Re: Amendment to the Project Description, Vegetated Swale
San Francisco Electric Reliability Project (04-AFC-1)

Description of the Vegetated Swale

SAN FRANCISCO ELECTRIC RELIABILITY PROJECT
SAN FRANCISCO, CALIFORNIA

MUNI SITE
GRADING AND DRAINAGE PLAN

DRAWING NO. C1.2 REV C

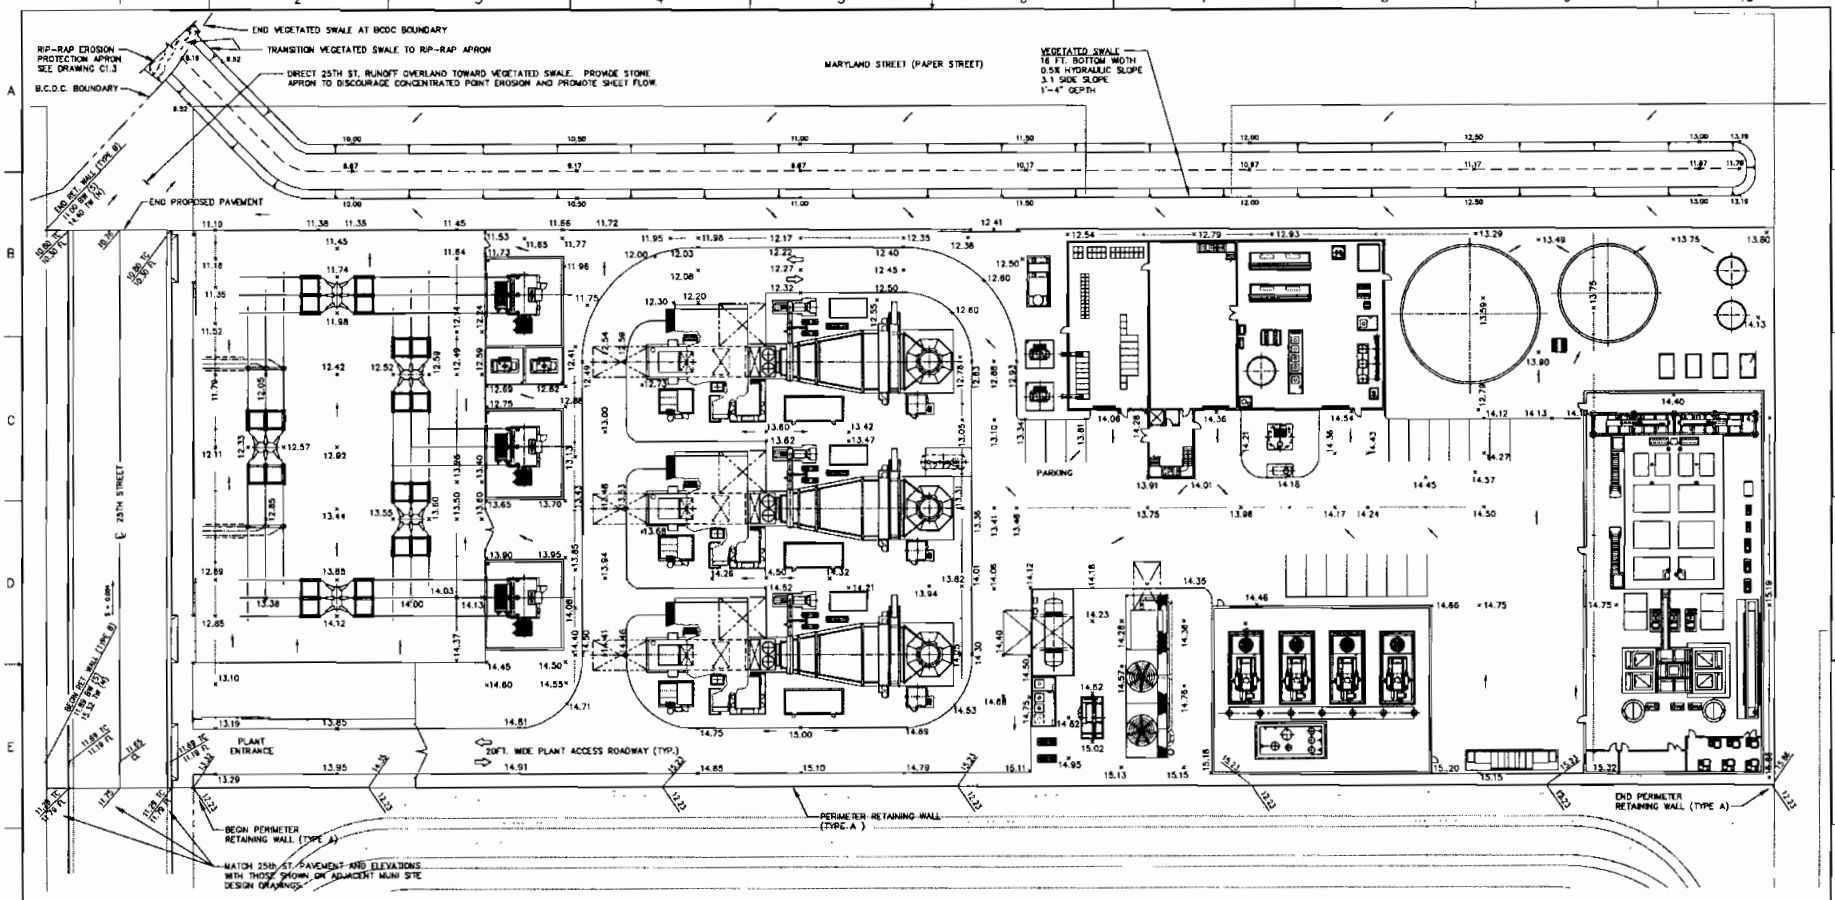
I am advised by my client that in subsequent discussions with the Port of San Francisco, it was determined that new Port of San Francisco stormwater best management practices (BMPs) would apply. According to the BMPs, the plant's stormwater would have to be discharged into the bay through the use of vegetated swales. Stormwater from the site would sheet flow easterly to a vegetated swale that would flow northward into the bay. This information was first related to staff in Informal Data Response Set 6C. By this letter, the City is formally amending the portion of the project description describing how stormwater would be handled. To facilitate Staff's review of this approach, the City is providing the following documents:

Post-construction treatment of stormwater will be accomplished by directing sheet flow from both the power plant site and 25th Street in front of the power plant into a Best Management Practices (BMP) stormwater treatment feature – a dry, vegetated swale. This method of stormwater collection and transport properly treats the stormwater prior to its discharge into the bay. Both the plant site and the street are impervious surfaces so the runoff coefficient for collection is conservatively assumed to be 0.99. The area between the plant site and the swale (as well as the area between the street and the swale) will be surfaced with vegetation similar to the grass in the swale. A membrane will be installed under the surface to ensure that no storm water percolates into the subsurface but rather is transported to the swale. From the swale, the water will then be transported to the Bay Conservation and Development Commission (BCDC) boundary where it will flow, after treatment, into the Bay via an outfall that spans the BCDC zone (see Figures C1.2 and C1.3).

SYMBOL	DATE	REVISION DESCRIPTION	DRAWN	APP'D
C	10-25-05	ADDED RIP-RAP APRON		
B	10-20-05	INCREASED VEGETATED SWALE DEPTH		
A	8-8-05	PRELIMINARY ISSUE

1. GRASS HEIGHT IN SWALE TO BE 8 INCHES. WATER QUALITY FLOW DEPTH TO BE 4 INCHES. SELECT FINE, CLOSE-GROWING, WATER RESISTANT GRASSES AS SWALE VEGETATION.

2. MINIMUM HYDRAULIC RESIDENCE TIME IS 10 MINUTES
3. SIDE SLOPES TO BE NO STEEPER THAN 3:1 (H:V) LONGITUDINAL SLOPE TO BE 0.50%.
4. MINIMUM SWALE LENGTH TO BE 100 LINEAR FEET.

5. NO INFILTRATION INTO SUBSURFACE SOILS IS PRESUMED. FLEXIBLE, WATERTIGHT GEOMEMBRANE TO BE INSTALLED 3 TO 3 1/2 FEET BELOW THE VEGETATED SWALE.
6. SURFACE MATERIALS IS PRESUMED SUITABLE TO SUSTAIN RUDERAL VEGETATION, BUT MAY REQUIRE SUPPLEMENTAL PLANTING TO SUSTAIN SWALE GRASSES. VEGETATION TO COVER SWALE BOTTOM AND SIDES

DRAWING NO. C1.3 REV C

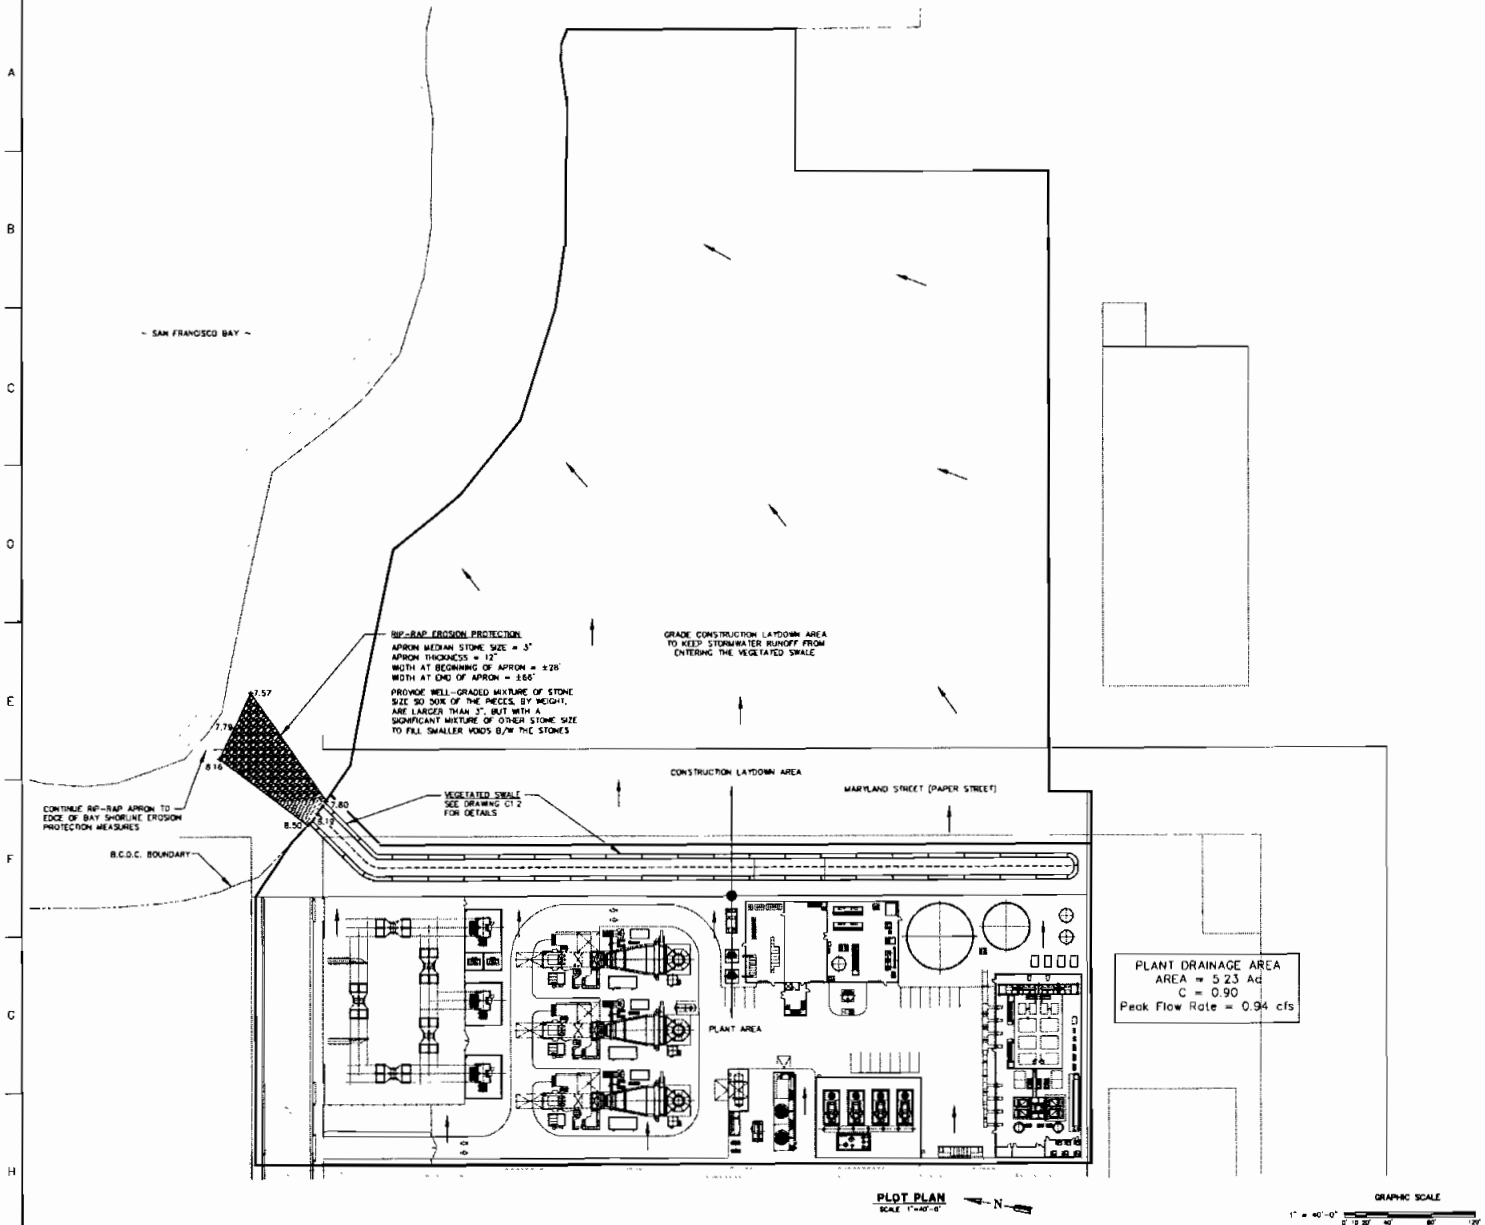
C	10-25-05	ADDED RIP-RAP APRON		
B	10-20-05	INCREASED VEGETATED SWALE DEPTH		
A	8-9-05	PRELIMINARY ISSUE		
PHASE	DATE	REVISION DESCRIPTION	DRAWN	APP'D
